Mesa 500-kV Substation Project CPUC Minor Project Change Form

Report No.: 05

RE: Mesa 500-kV Substation Project – Minor Project Change No. 5 Request: Installation of three new switches

MESA 500KV SUBSTATION
NEW MESA SUBSTATION
OVERHEAD POLE SWITCHES
FOR MINOR PROJECT CHANGE FIVE

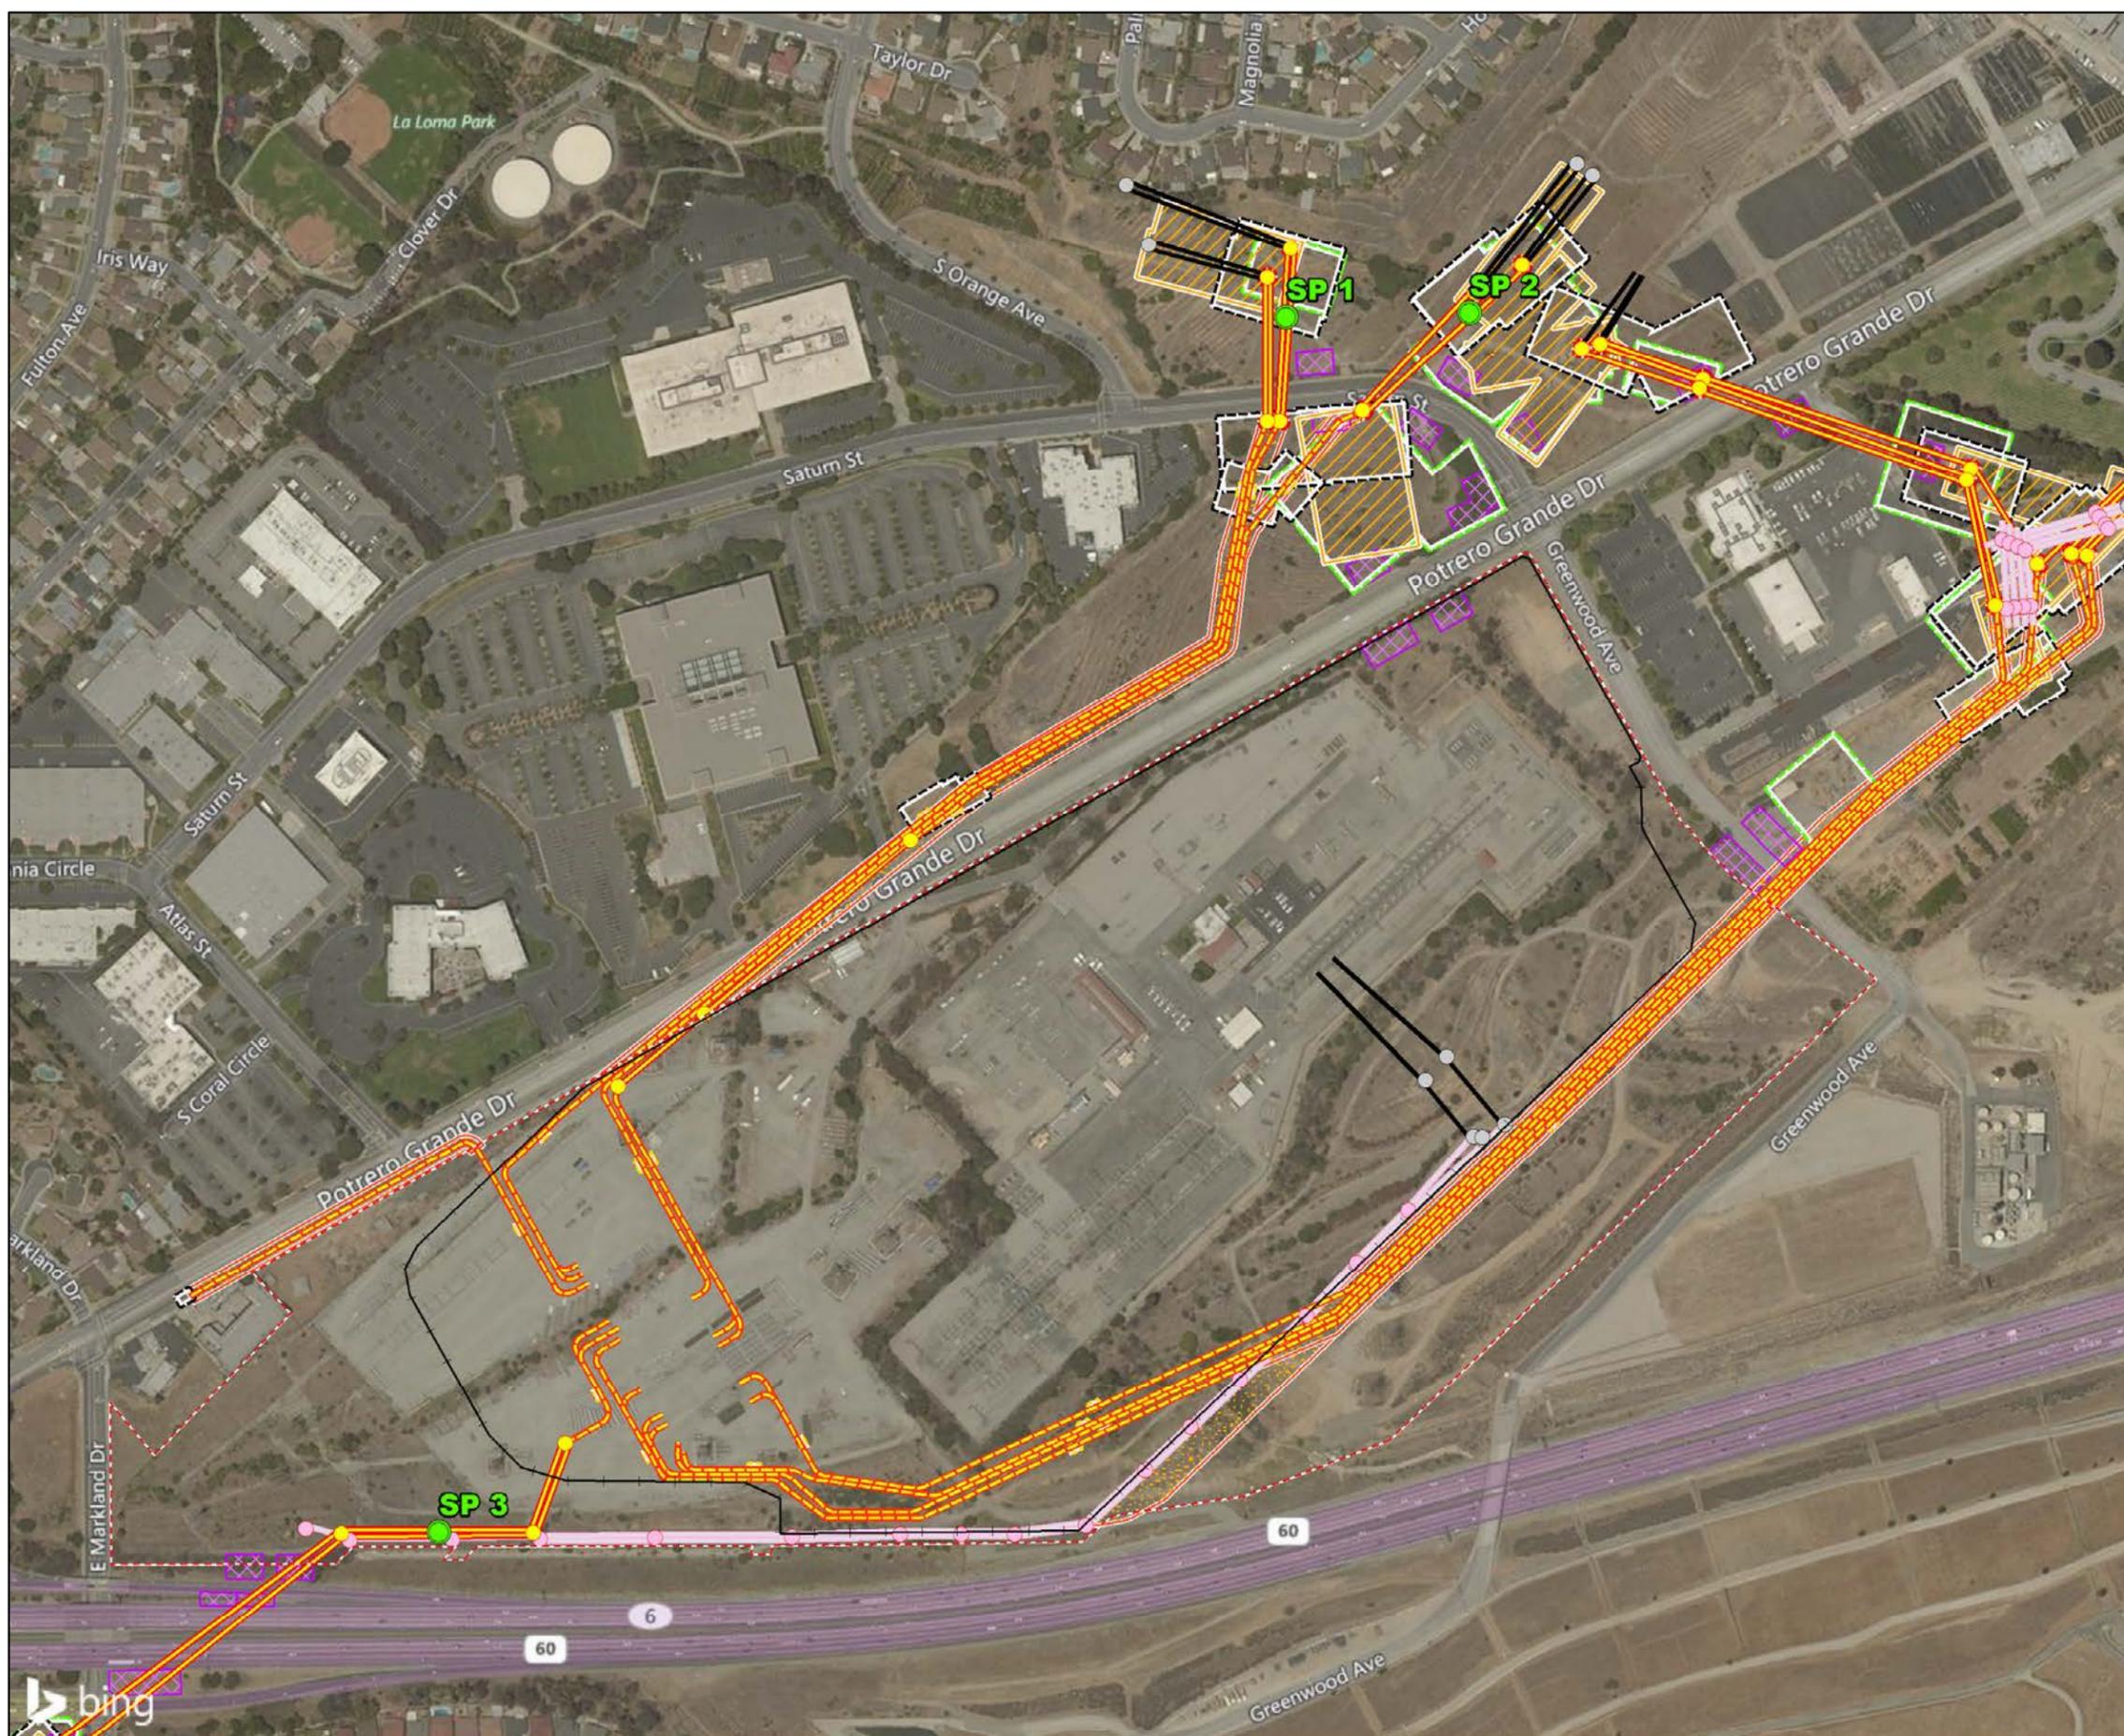
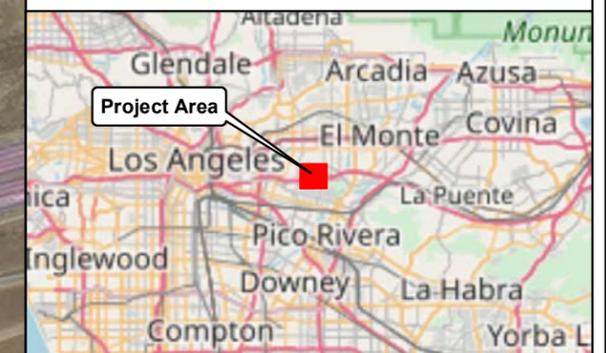
- Original Condition: Currently, there is no way to isolate the newly installed underground getaway cables between the 66 kV switchrack and the subtransmission riser poles, the locations where the proposed switches are to be installed. Without these switches, if there were ever an issue with one of those underground cables, the entire circuit would need to be de-energized in order for a crew to safely work on the repairs.

- Justification for change: In order to provide additional operating flexibility, these switches will be installed between the switchrack and the subtransmission riser poles. With the switches, the portion under repair can be separated from the balance of the circuitry, allowing for power to flow between other substations that are connected to the circuit in question. For this change, SCE will install new switches on three 66kV circuits. One switch will be installed on a new stronger pole in the same location as pole 6604, near the 60 freeway (existing pole to be replaced). The second switch will be installed on a new pole to be located on the north side of Saturn Ave in between poles 6608 and 6609. The third switch will be installed on a new pole to be located on the north side of Saturn Ave between poles 6611 and 6612.

- Figure: Attached to this document.
 - Figure. New Mesa Substation Overhead Pole Switches
- Environmental Impact:

MESA 500KV SUBSTATION
NEW MESA SUBSTATION
OVERHEAD POLE SWITCHES
FOR MINOR PROJECT CHANGE FIVE

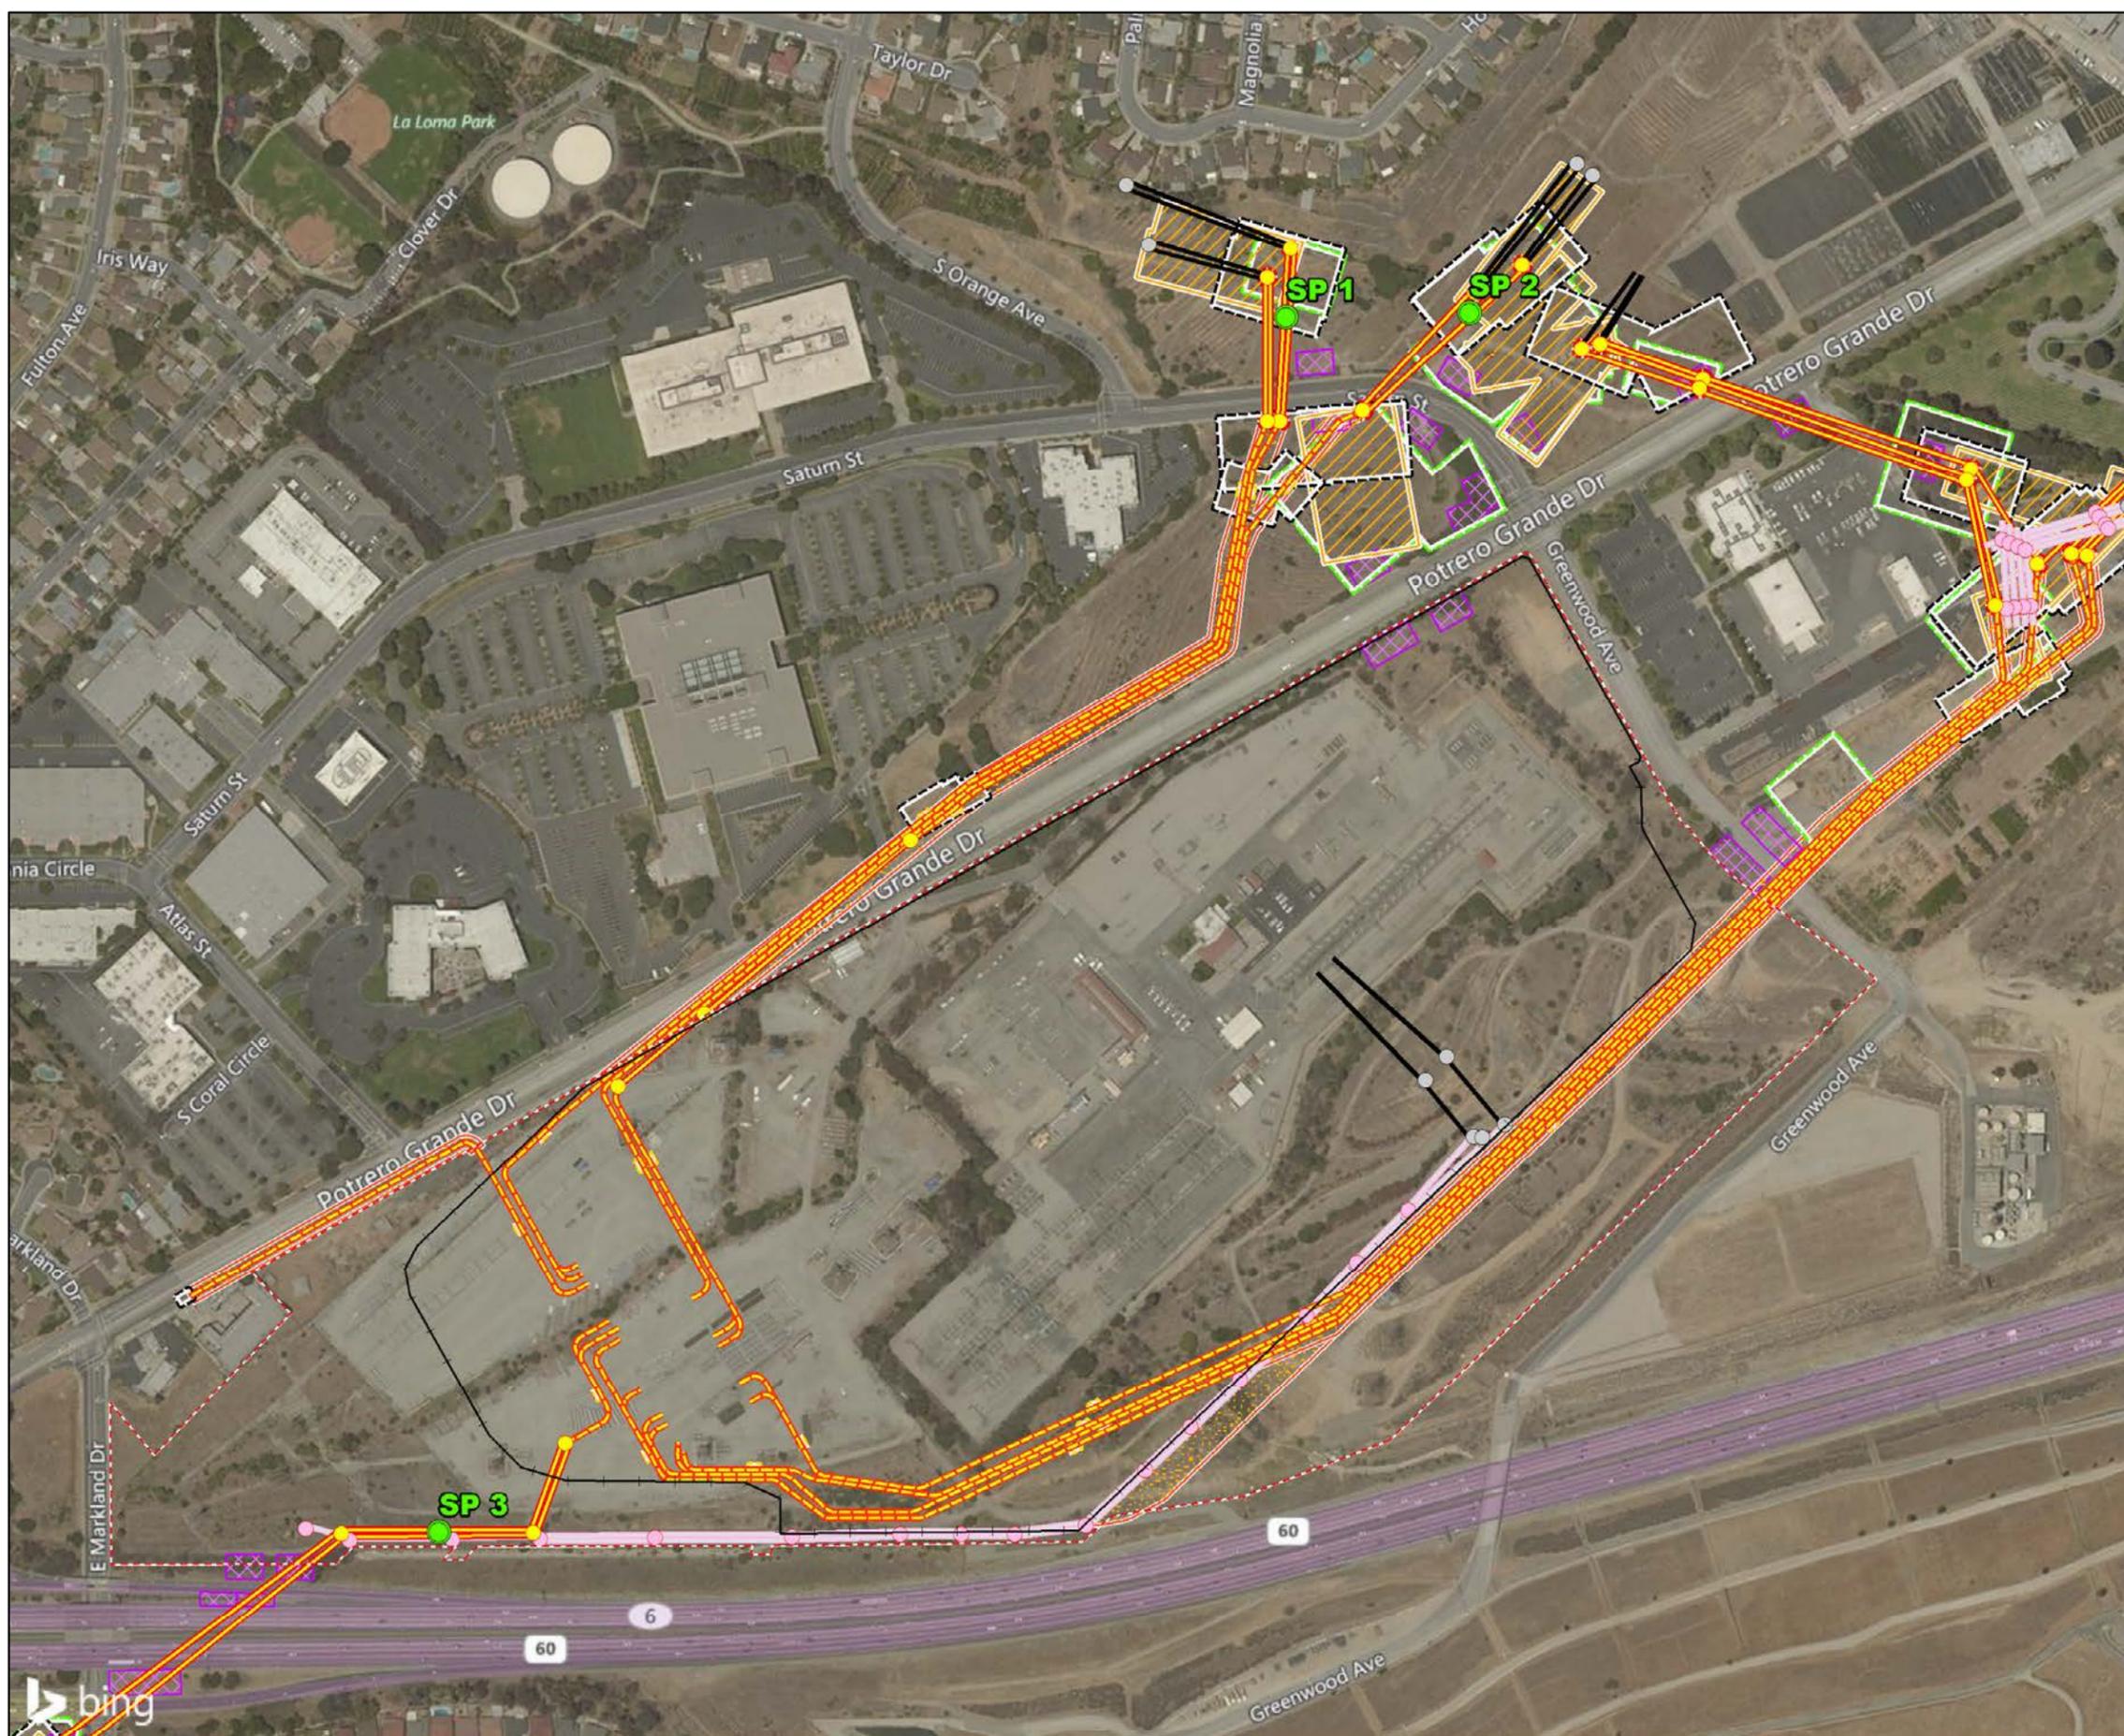
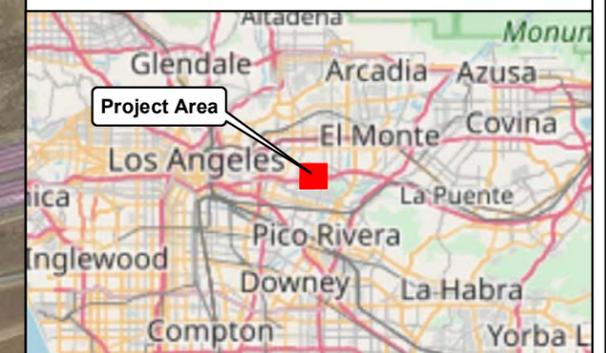
On December 20, 2018, Southern California Edison (SCE) submitted Minor Project Change (MPC) No. 5 Request to the California Public Utilities Commission (CPUC) for review. The proposed MPC would involve the installation of new switches on three 66-kV circuits. Two switches (SP 1 and SP 2) would be installed on new poles to be located on the north side of Saturn Avenue; SP 1 would be installed between Pole 6608 and Pole 6609, and SP 2 would be installed between Poles 6611 and Pole 6612. The third switch (SP 3) would be installed on a new, stronger pole in the same location as Pole 6604, near California Highway 60; the existing pole (Pole 6604A) would be replaced by the new pole containing the switch. A figure of MPC No. 5 work areas and switch pole schematics are provided in Attachment 1. Installation of the three new switches would allow SCE to isolate the newly installed underground getaway cables between the 66-kV switchrack and the subtransmission riser poles, which are located where the proposed switches would be installed. Without these switches, if repairs are ever required on the new underground cables, SCE would need to de-energize the entire circuit to ensure that crews can safely work on the system.

MPC No. 5 would occur entirely within approved temporary work areas north of Saturn Avenue, and immediately north of California Highway 60. All work areas associated with MPC No. 5 activities fall within the Final EIR Study Area. SP 1 would be located within an approved work area north of Saturn Drive, SP 2 would be located within Staging Yard 1, and SP 3 would be located within the substation property boundary.

66KV SWITCH POLE #1

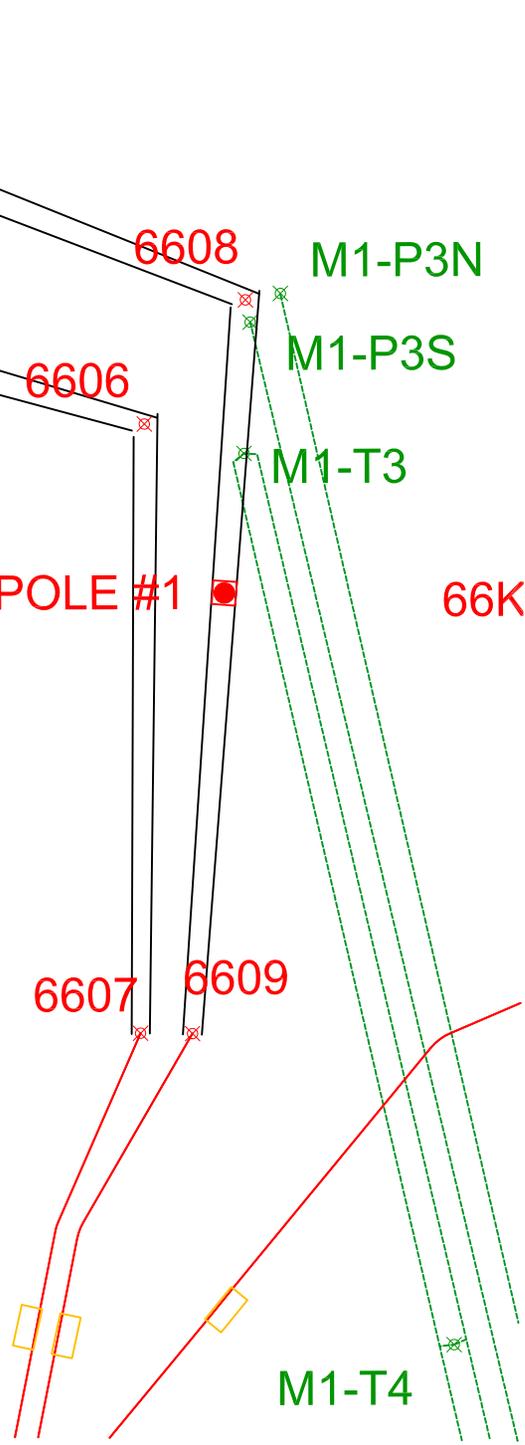
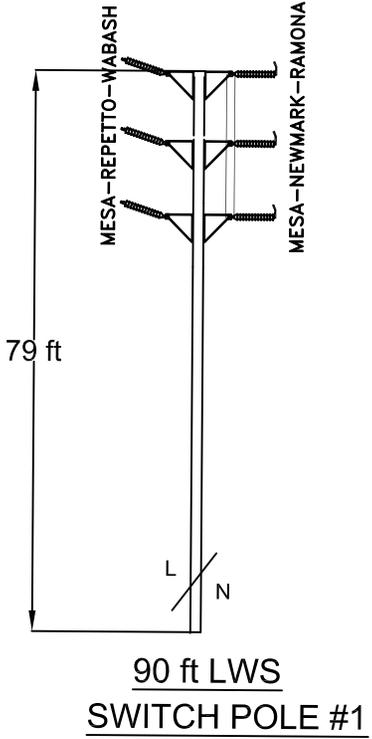
SP 1 and SP 2 would be installed on new poles approximately 79 and 84 feet tall (aboveground), respectively. SP 3 would be installed on a new pole approximately 88 feet tall (aboveground), which would replace the existing Pole 6604 within the same footprint. All three switches and associated poles would be set back more than 50 feet from the nearest public roadway, and would be consistent with the surrounding industrial viewshed. The three new switches would not be expected to substantially degrade the surrounding viewshed.
